UNITED STATES PATENT AND TRADEMARK OFFICE

10/849,378

Office Action Summary

DETAILED ACTION

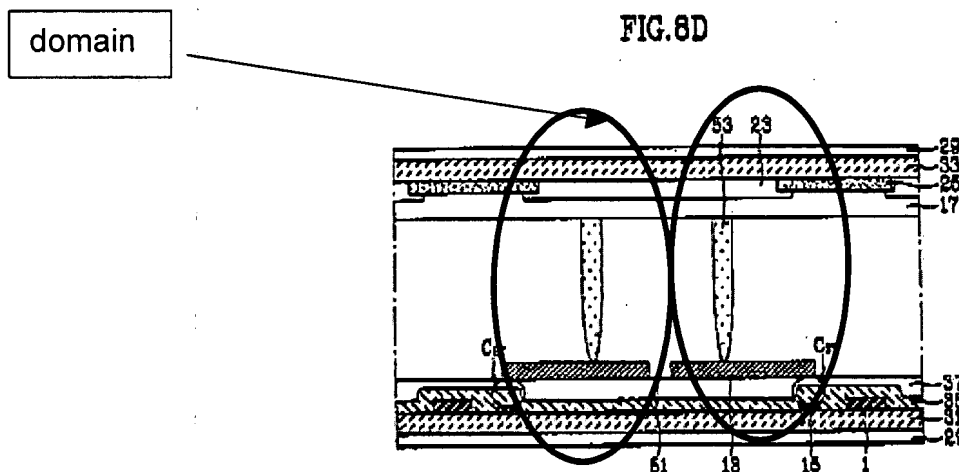
Regarding Claim 1,24,20

Kim et al (US 6774967) discloses (Figure 8D) a pair of substrate (31,33) respectively having electrodes (17,13) on opposing surfaces, the pair of substrates sandwiching a liquid crystal layer (the space between 17 and 13). A plurality of domains (shown below) formed within a display region when a voltage is applied to the electrodes, the plurality of domains being such that liquid crystal molecules are aligned in different directions from domain to domain, at least one of the electrodes on the pair of substrates having an aperture section (shown below). The liquid crystal layer having a plurality protrusion section (53) which connects the electrodes (17,13) Kim et al discloses (Figure 14) a aperture (51) and protrusion section (53) extending across the liquid crystal layer and which connects the electrodes, and wherein the aperture section is bend in such a manner that sides of the aperture and protrusion section extend in directions which respectively form about 45° with a long side and a short side of the

display region. And the bent parts of the protrusion section are located in regions corresponding to old portions of the electrode.

Kim et al does not disclose the protrusion sections are discontinuous.

Kim et al discloses (US 6356335). (Fig. 8e) the protrusion (57) are discontinuous (shown protrusions being separated) which are used to be provided to obtain multi-domain effect.

It would have been obvious to one of ordinary skilled in the art to modify Kim et al to include Kim et al's protrusion being discontinuous motivated by the desire to obtain multi-domain effect which widens the viewing angle to achieve a high brightness by stable arrangements of the liquid crystal molecules. (column 2, rows 1-5).

FIG.14

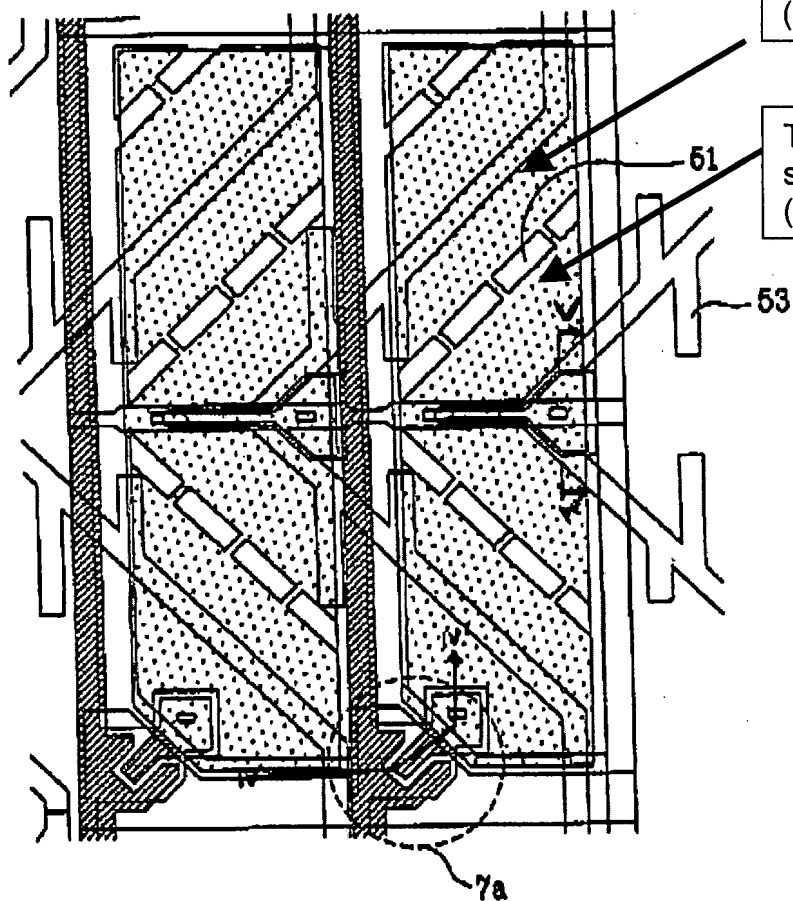
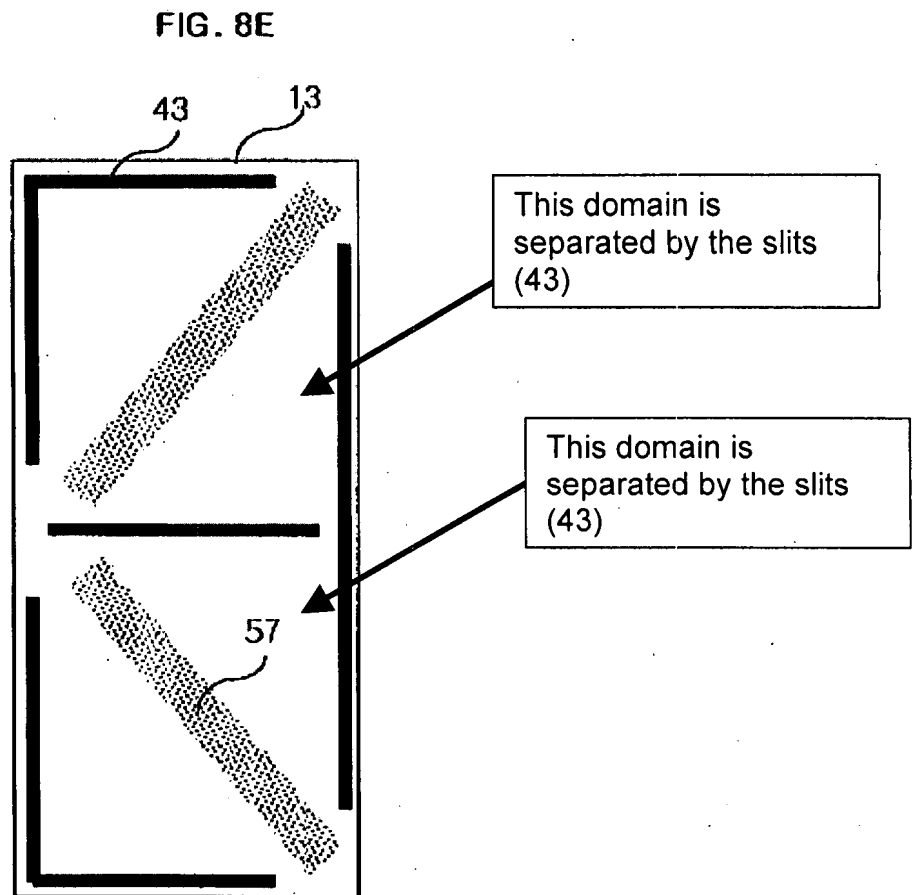
Applicant's arguments that "...Fig. 8e of Kim 2 are discontinuous is due to the presence of a slit 43 there between which prevents them from being connected." The bent parts of the protrusion section are discontinuous which provide a plurality of domains as shown below.

This domain is separated by the slits (51)

This domain is separated by the slits (51)
